C-900 - ADDENDUM

Addendum No. 3

Date:	<u>March 29, 2019</u>
Issued To:	<u>Plan Holders</u>
From:	<u>Alan Plummer Associates</u>
Project:	<u>Wastewater Treatment Plant Expansion</u>

MECHANICAL PIPING PLAN

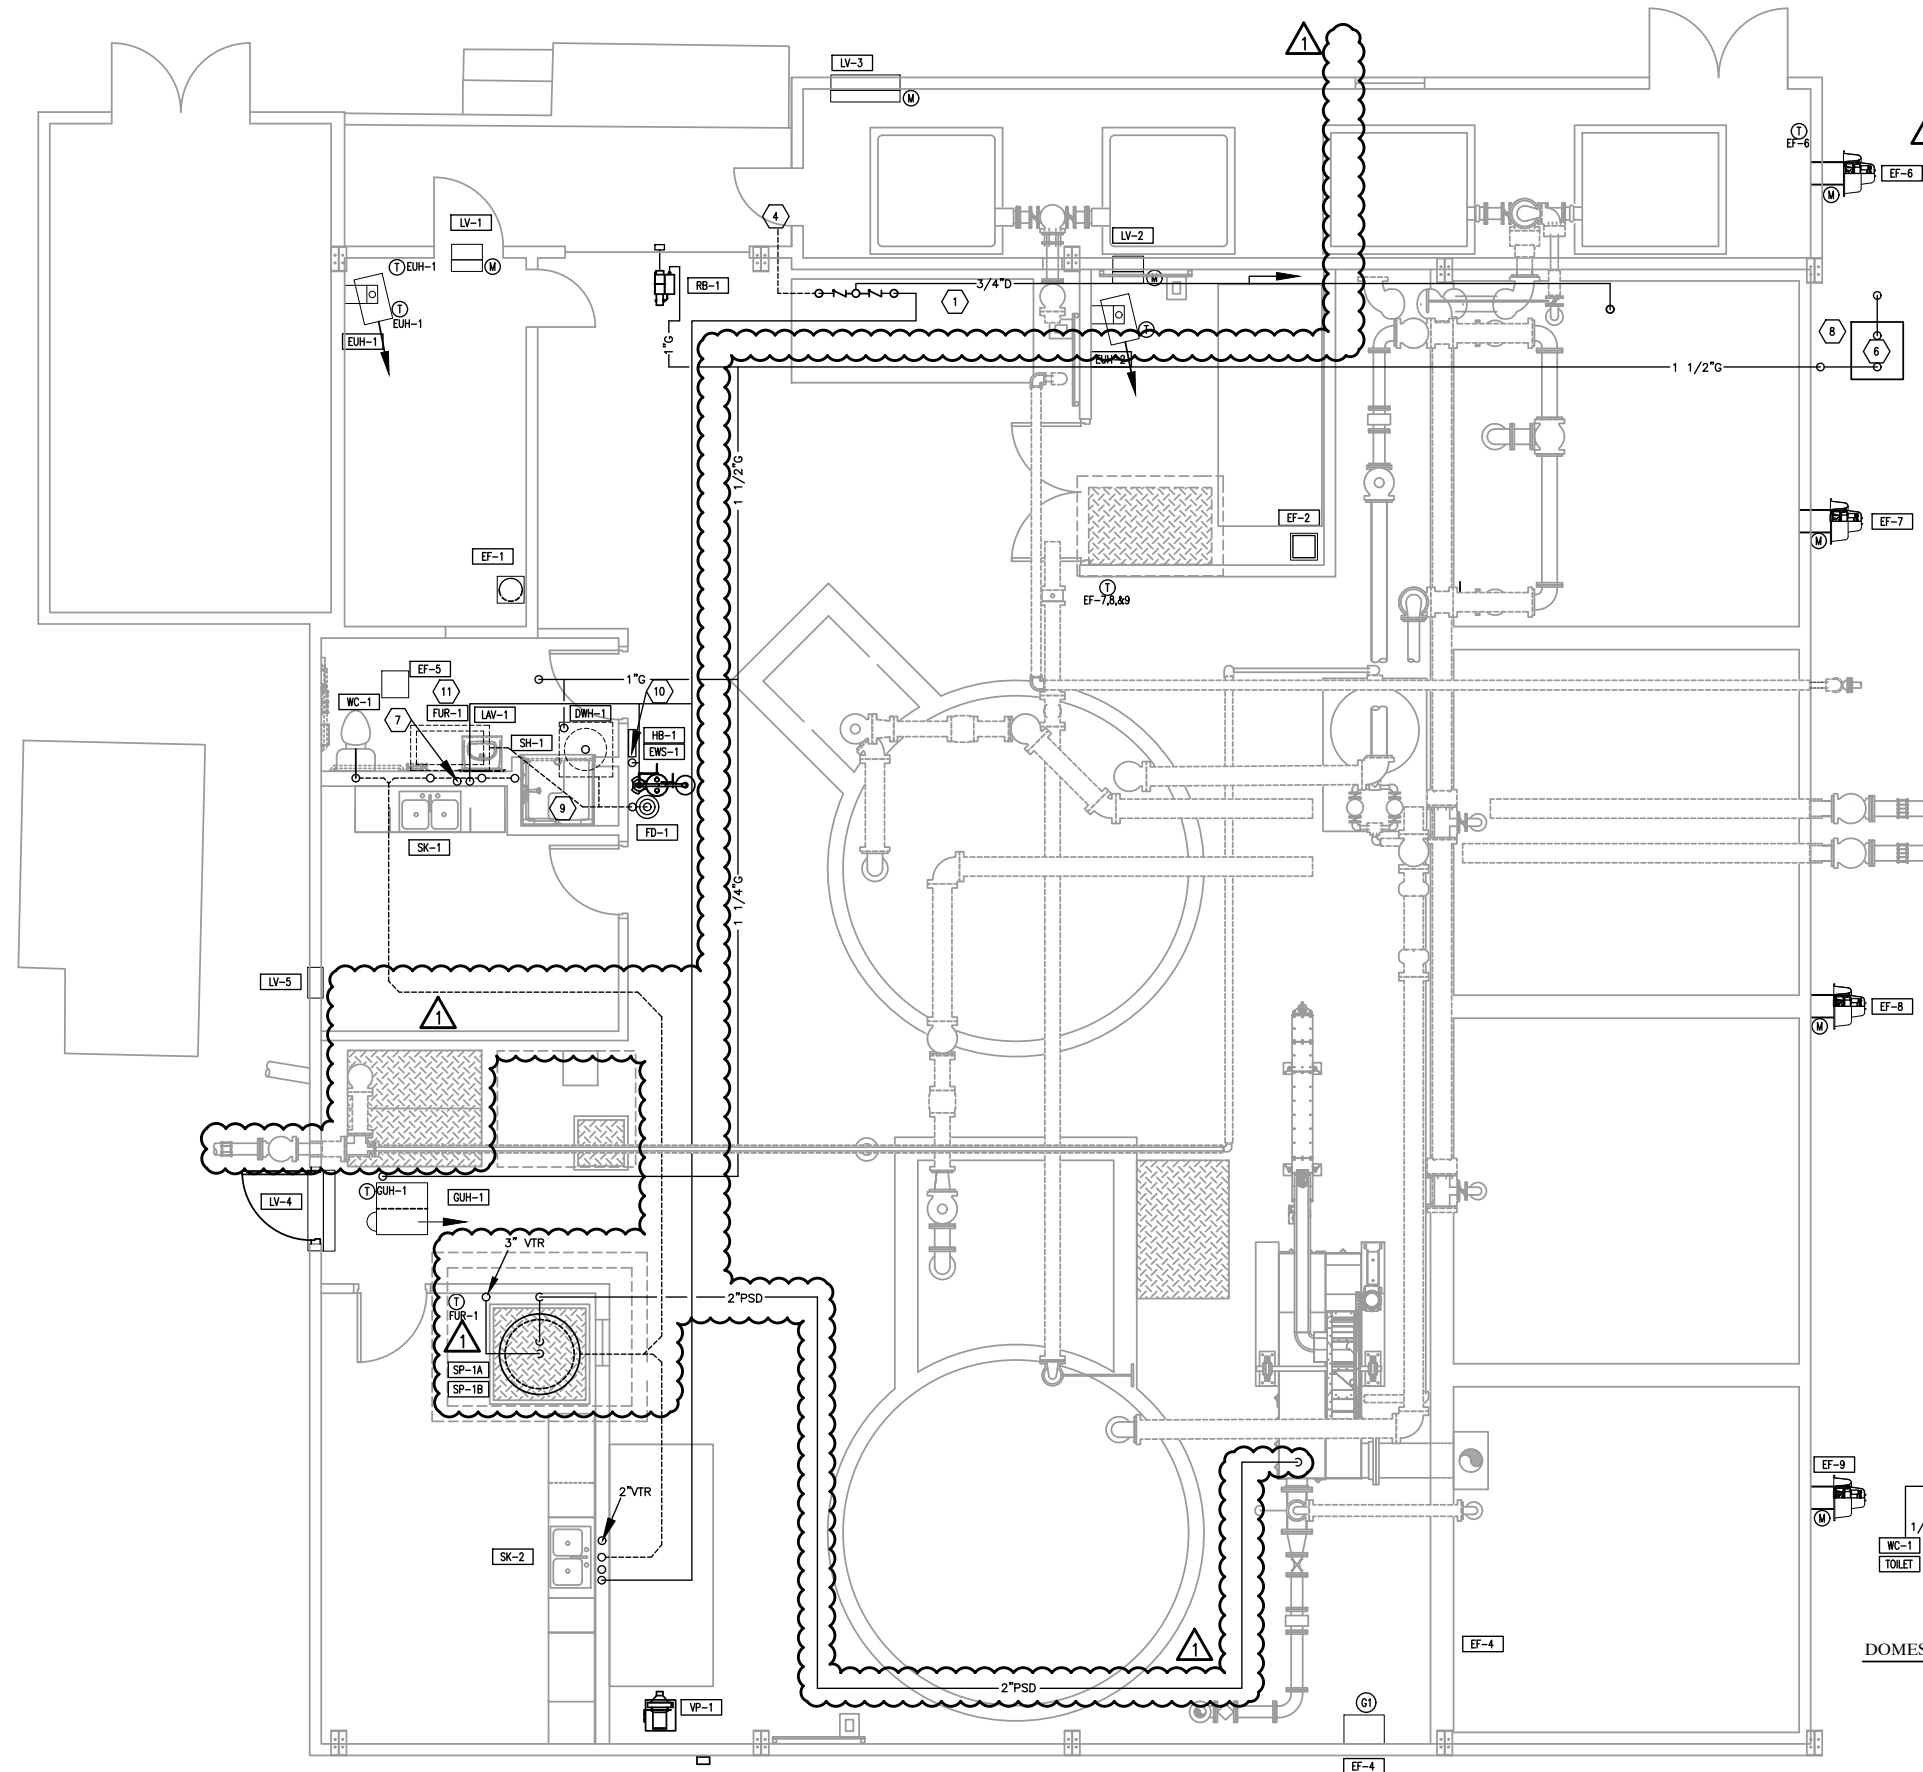
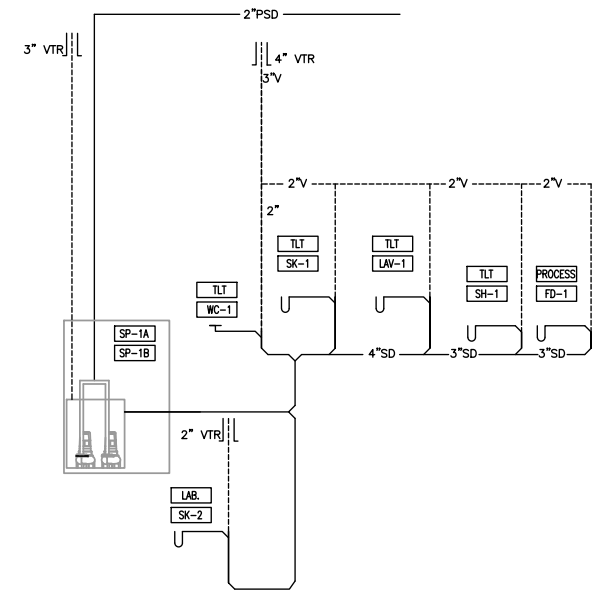
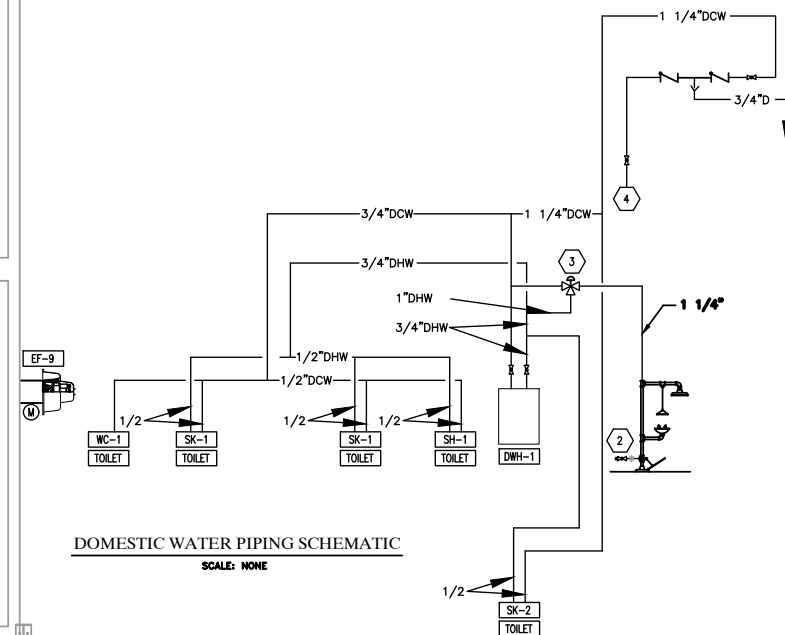
1. Response: The pipe penetration details will be coordinated with the metal building manufacturer's system-specific details.
- H. P1-02 - Note 4 says to reference mechanical for lift station - where is this reference? What is spec on lift station pumps?

1. Response: Refer to Mechanical Sheet No. M2 for the lift station location. Refer to Pump Schedule in Mechanical Sheet No. M4 for pump model.
- I. Do the MBR tanks need a thickened pad/foundation in addition to the 4" equip. pad?
